# Error ratio for coherent PHY types

## Draft 1.4 comments 16, 115, 117, 118

Matt Brown, Alphawave Semi

# Introduction

# 800GBASE-LR1 PHY (single-lane coherent, 10 km)

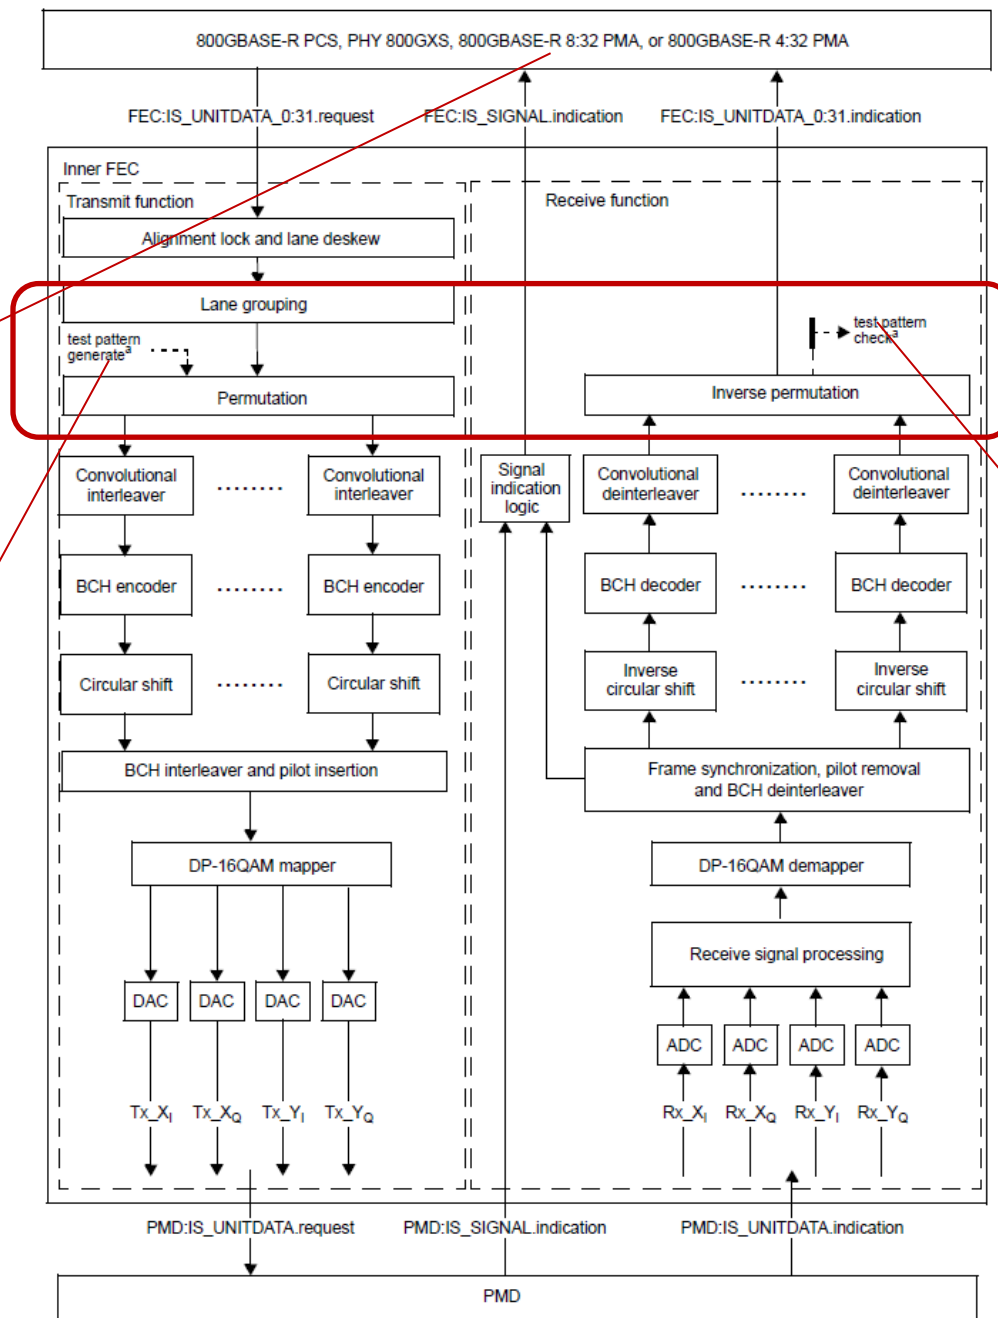
For this Inner FEC, the interface to the sublayer above is 32 PCS lanes, i.e., not one lane per PMD lane.

Implement block error counters on the PMA would require 32 instances and they'd all have to be convolved together.

Single PRBS31 pattern generator here

The pattern from a single generator is round-robin distributed to each of the 32 FEC flows.

Single PRBS31 pattern checker here

The pattern from 32 FEC flows is reassembled then processed by the checker.

Corresponds well to the single optical lane.

Figure 174A-X—Test configuration for 800GBASE-LR1 PMD

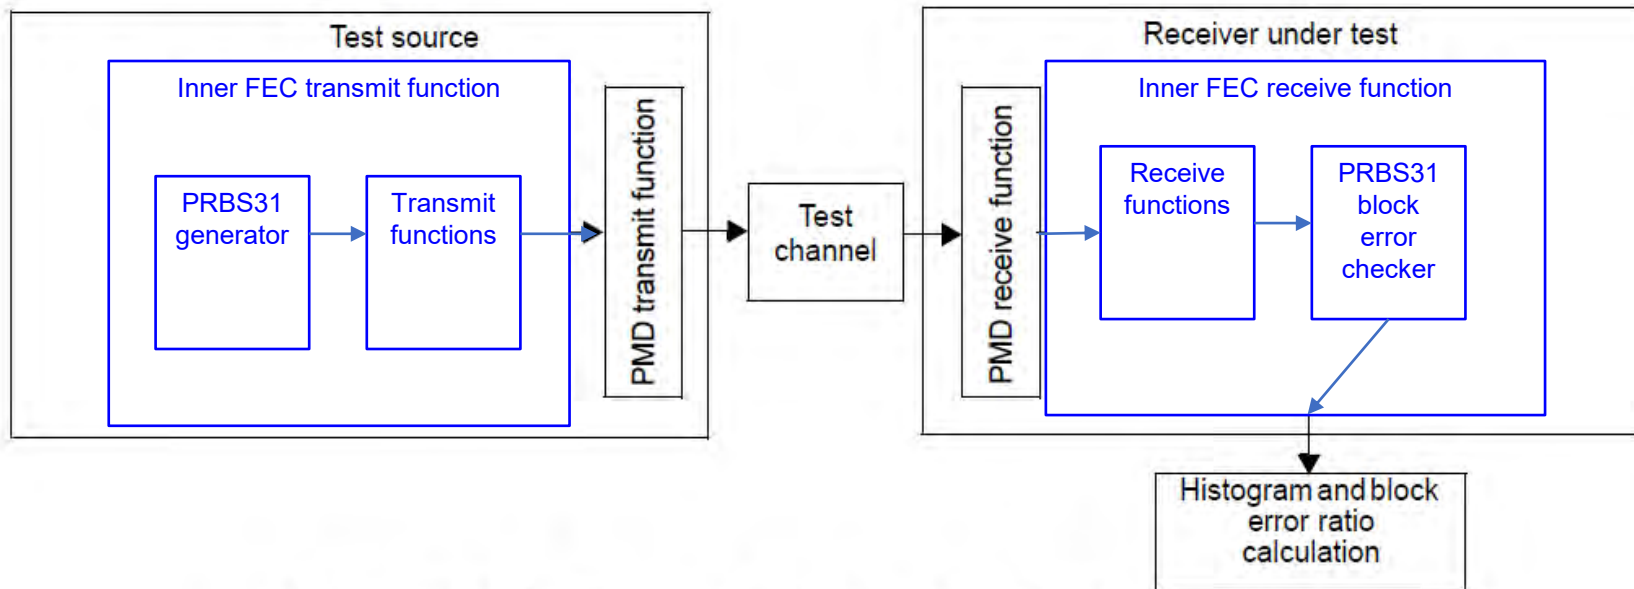
Add new test configuration diagram in 174A.x.1.1

# Draft 1.4 error ratio allocations for 800GBASE-ER1/ER1-20 Physical Layer Implementations

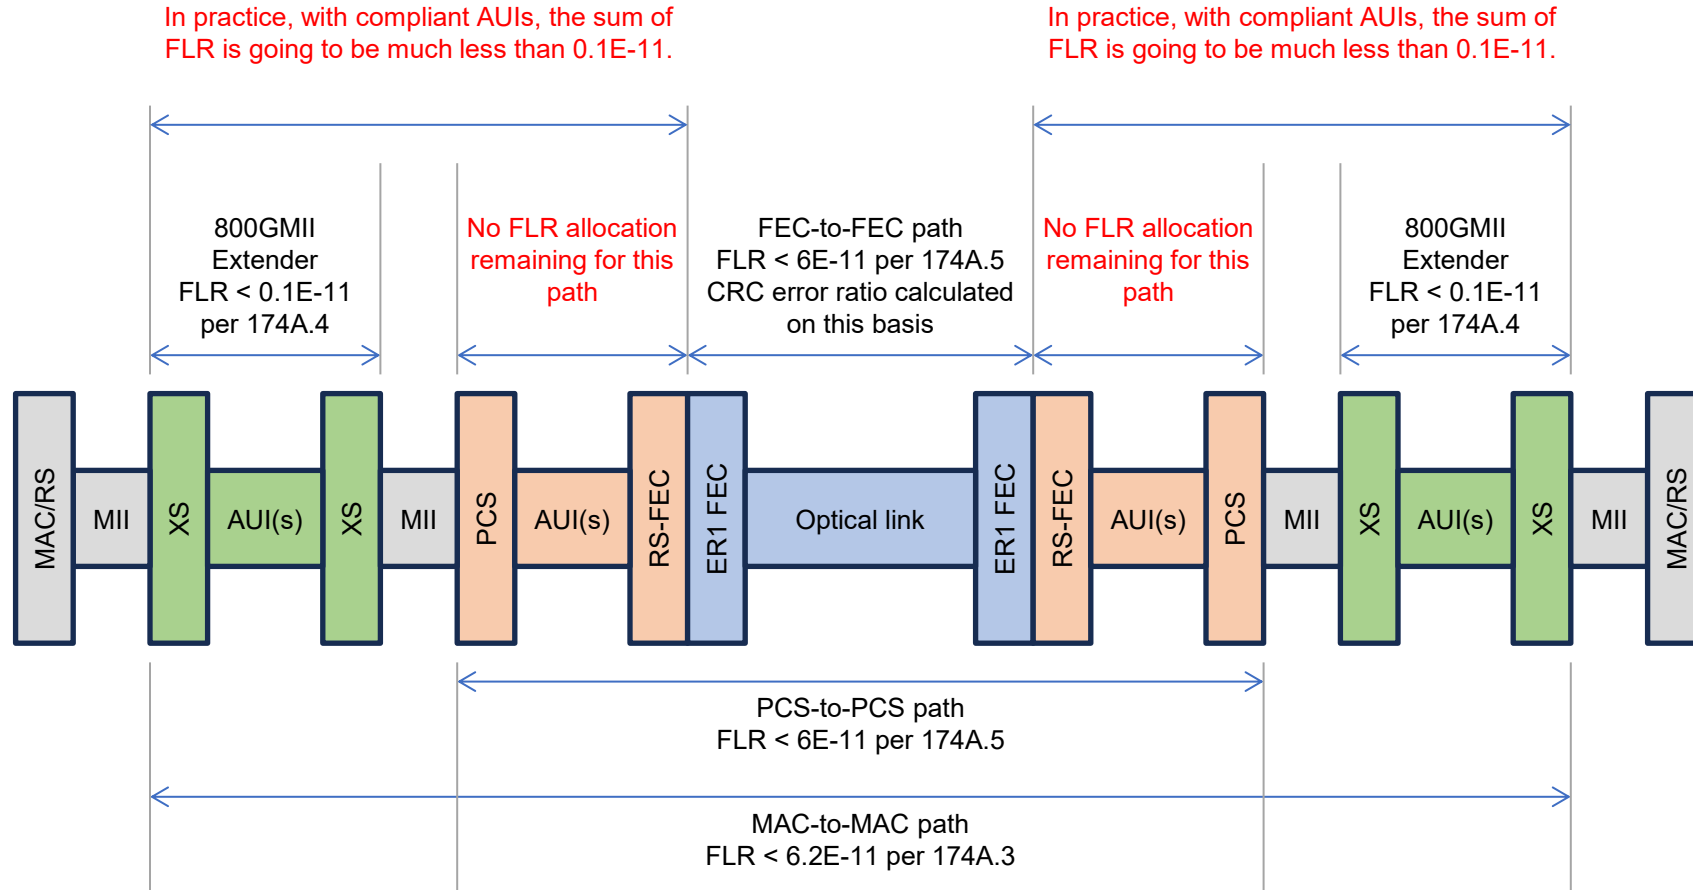
Cl 174A	SC 174A.6	P 662	L 31	# 16
Brown, Matt		Alphawave Semi		
Comment Type	T	Comment Status	X	
CRC error ratio based on 6E-11. However, this would not account for an Extender plus a pair of AUIs in the PHY. Options:				
(a) disallow extender				
(b) state that either extender or AUIs in PHY, but not both				
(c) reduced FLR for PCS-to-PCS to 5.8E-11.				
<i>SuggestedRemedy</i>				
A contribution will be provided.				
<i>Proposed Response</i>		<i>Response Status</i> O

Not accurate. This table is for optical PHYs with concatenated Inner FEC. This table does not apply to optical PHYs with a segmented FEC, like 800GBASE-ER1/ER1-20.

There is ample margin in the xMII extender budget that might be shared between the xMII extender and the RS-FEC to RS-FEC path on the PHY.

For random BER of 0.34E-4, FLR of 2.5E-25 can be supported on each path. Therefore, in practice, with compliant AUIs, the sum of FLR for the xMII Extender and the RS-FEC path will be far below 0.1E-11.
